From: sun wo wong [REDACTED]
Sent: 2025-08-22 星期五 12:01:40
To: [REDACTED]
Subject: tpbpd/PLAND <tpbpd@pland.gov.hk>
A/YL-PH/1055
Attachment: 回應部門的提問 22-08-2025.pdf; 模擬行車路線圖.pdf

回應部門提問

A/YL-PH/1055

模擬行車路線圖

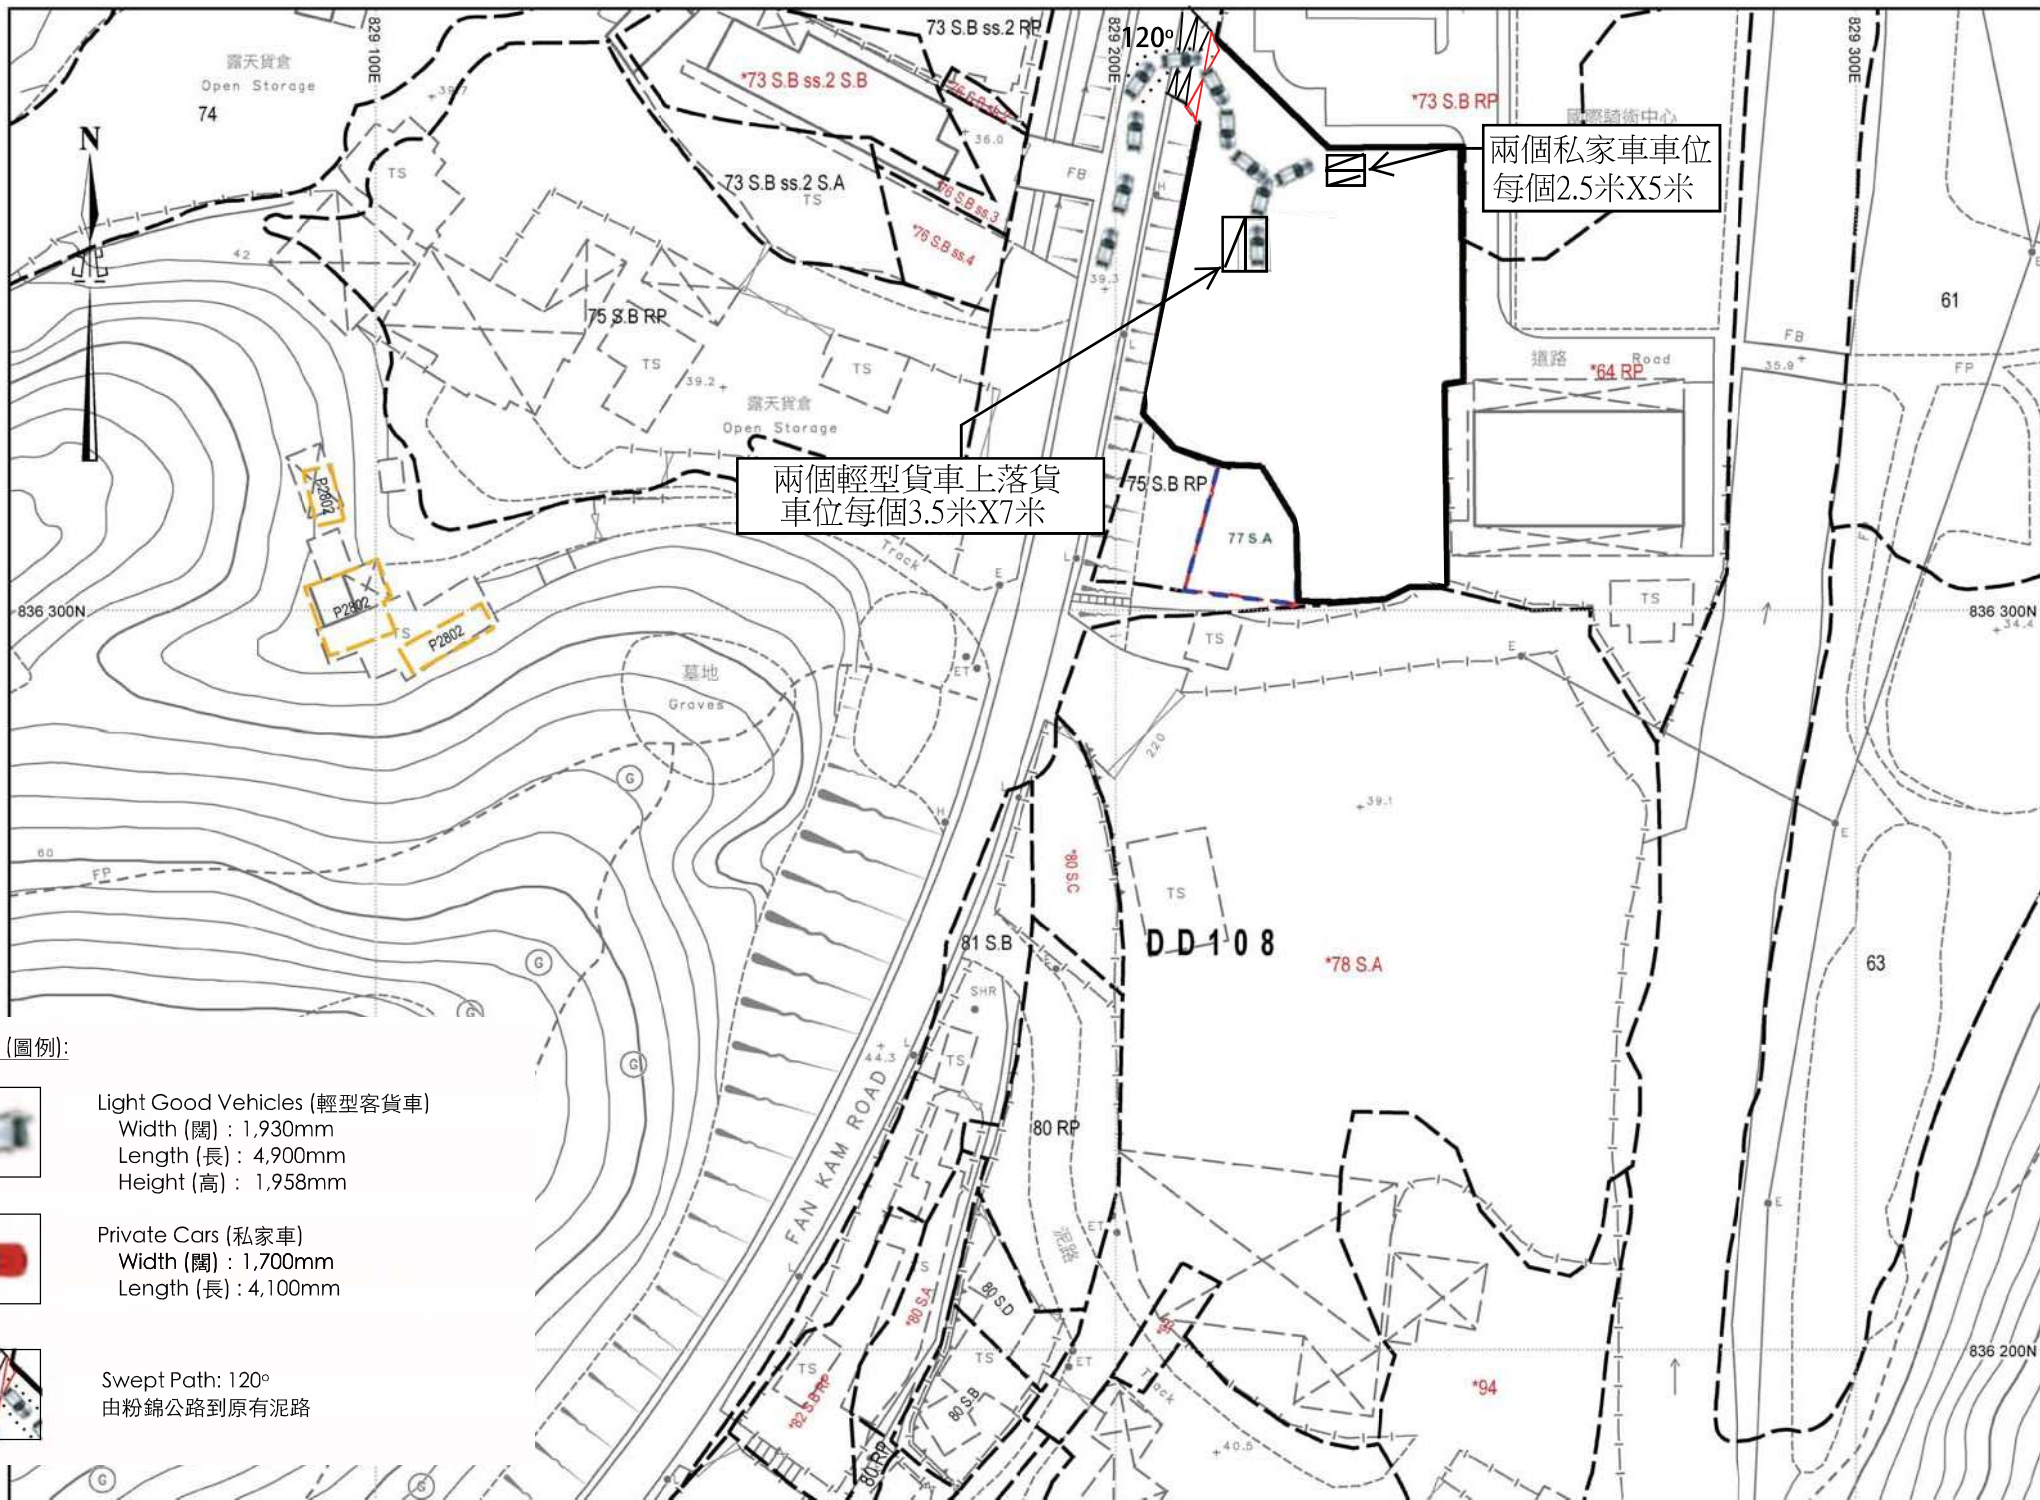
- (2) A run-in/out proposal is required. The applicant should ensure a run-in/out is constructed in accordance with the latest version of HyD Standard Drawings No. H1113 and H1114, or H5133, H5134 and H5135, whichever set is appropriate to match with the existing adjacent pavement. 有關路口早前已依照 HyD Standard Drawings No. H1113 and H1114, or H5133, H5134 and H5135,的指引建做，我等會連同附件一並附上車輛出入模擬圖給貴署參考。
